MIDLAND PROJECT
DOCKET NUMBERS 50-329 50-330
REGULATORY GUIDE MEETINGS
FILE: 0505 SERIAL: 1962

The enclosed information responds to Mr. A. Schwencer's October 31, 1975 letter requesting additional information regarding implementation of Regulatory Guides for the Midland Plant. These guides deal with structural engineering, the emergency cooling pond and flooding, and were discussed with your staff on September 24, 1975.

Reg. Guide 1.10

FIGURE 2

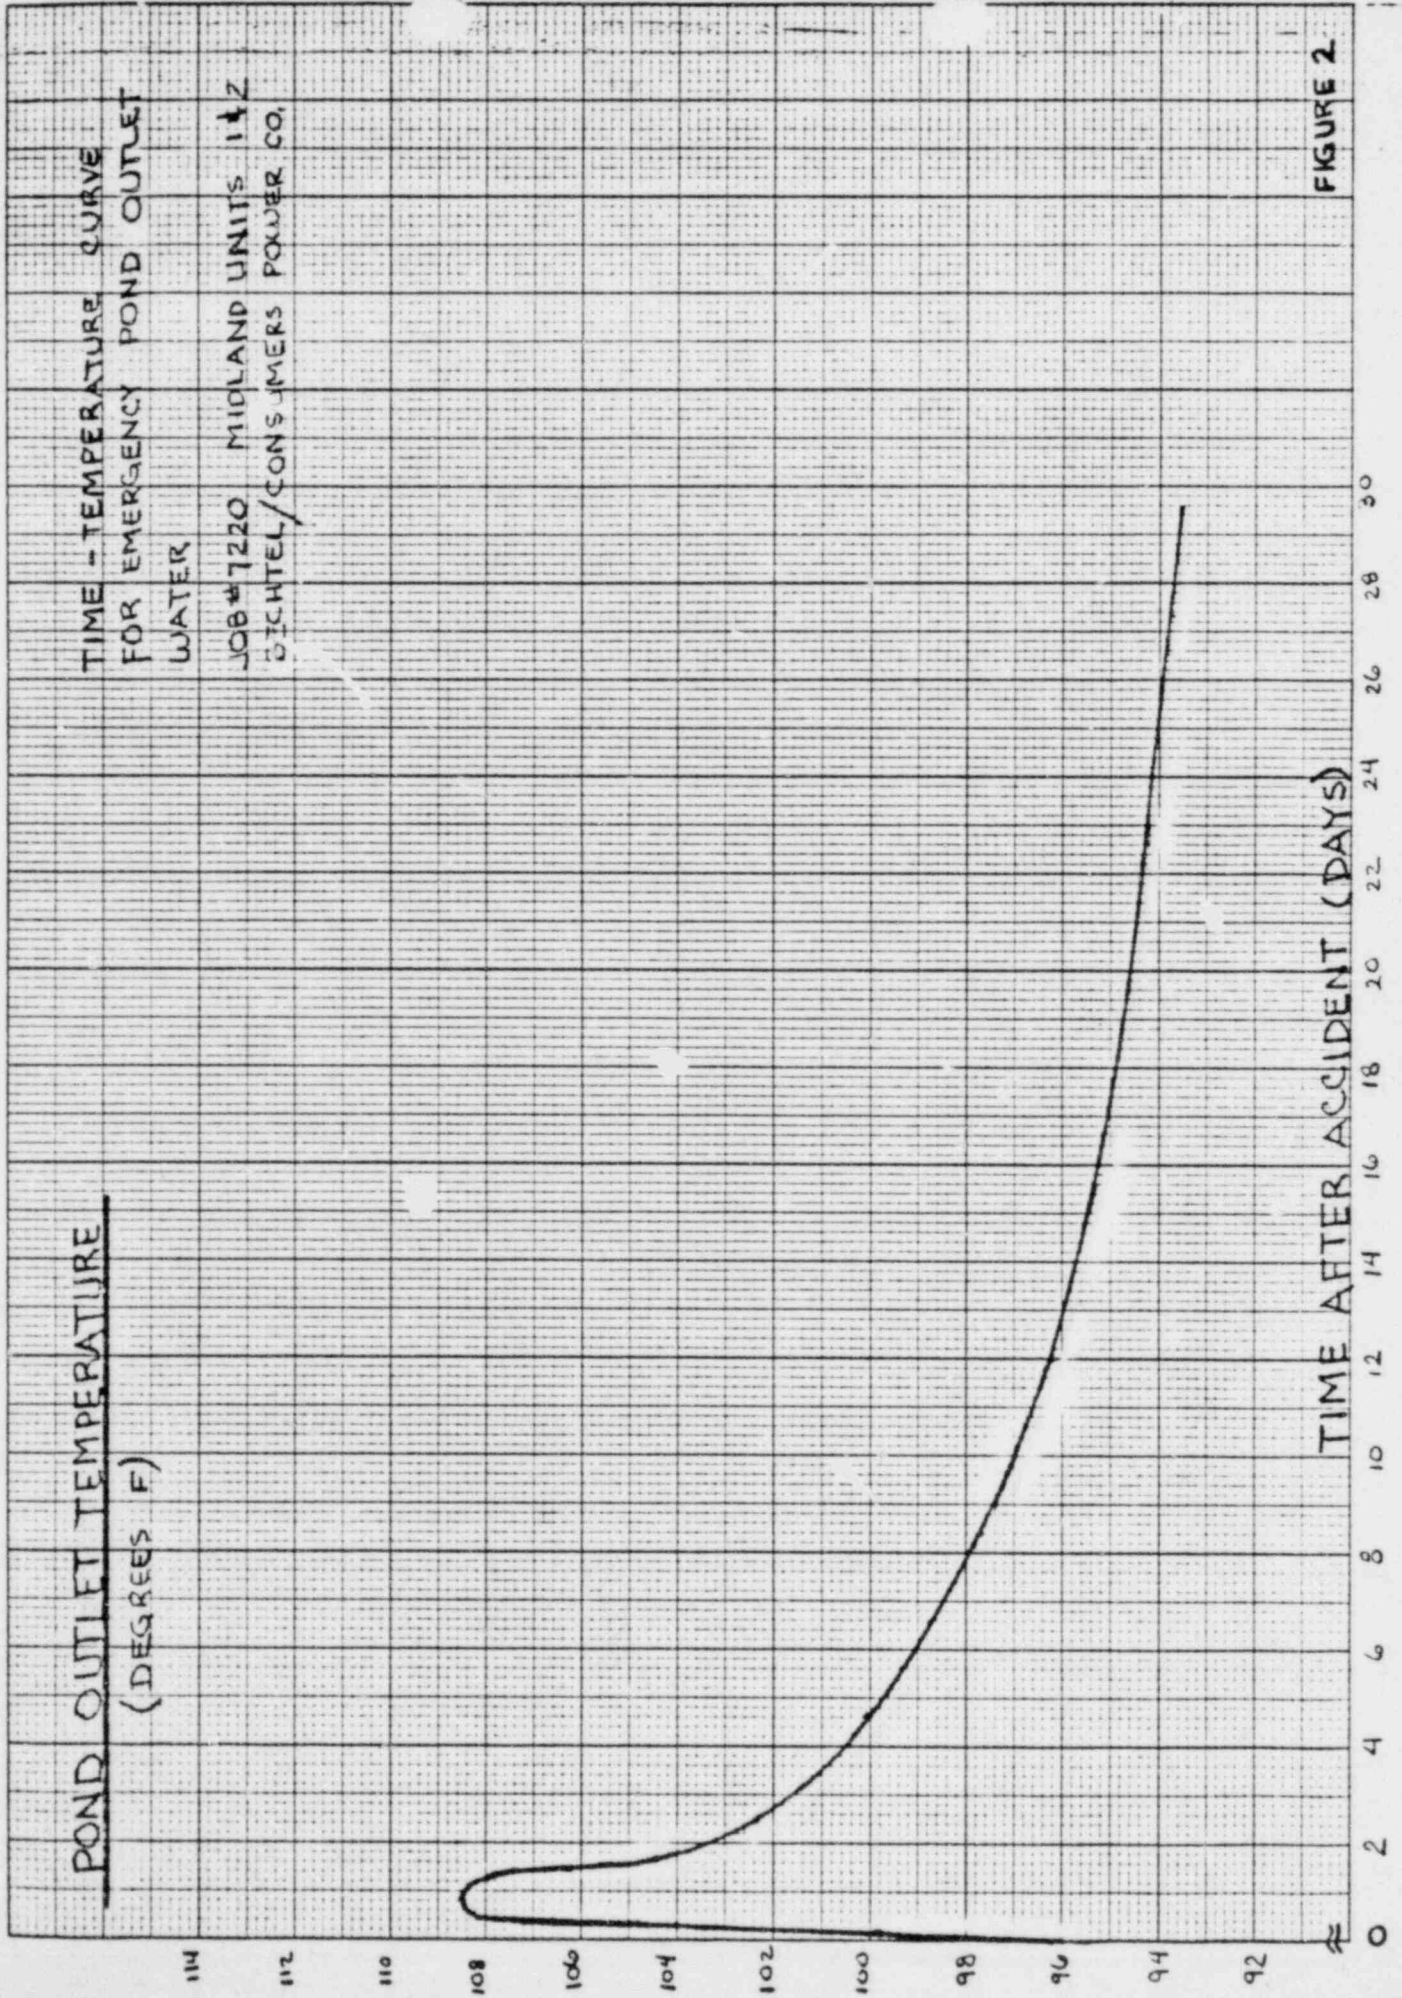
- (2) Initial emergency pond temperature;
- (3) Emergency pond geometry (and figure of pond) and normal operating level;
- (4) Location on emergency pond intakes and discharges (locate on figure provide for item (3));
- (5) The heat curve (in BTU-hour) for various times throughout the entire 30-day period.

The ultimate heat sink for the Midland Plant, Units 1 and 2, has been analyzed in accordance with Regulatory Guide 1.27, Rev. 1. Analysis of the ultimate heat sink, consisting of a cooling pond, included computation of a worst case time-temperature relationship for water losses for the first 30 days of pond operation following a design basis accident. The time-temperature relationship for pond outlet water is given in Figure 2.

The peak pond outlet temperature following a design basis accident was computed to be about 108.5°F for an initial emergency pond temperature of 96°F. Total pond evaporative water loss during the first 30 days of operation following the design basis accident was computed to be approximately 17 inches.
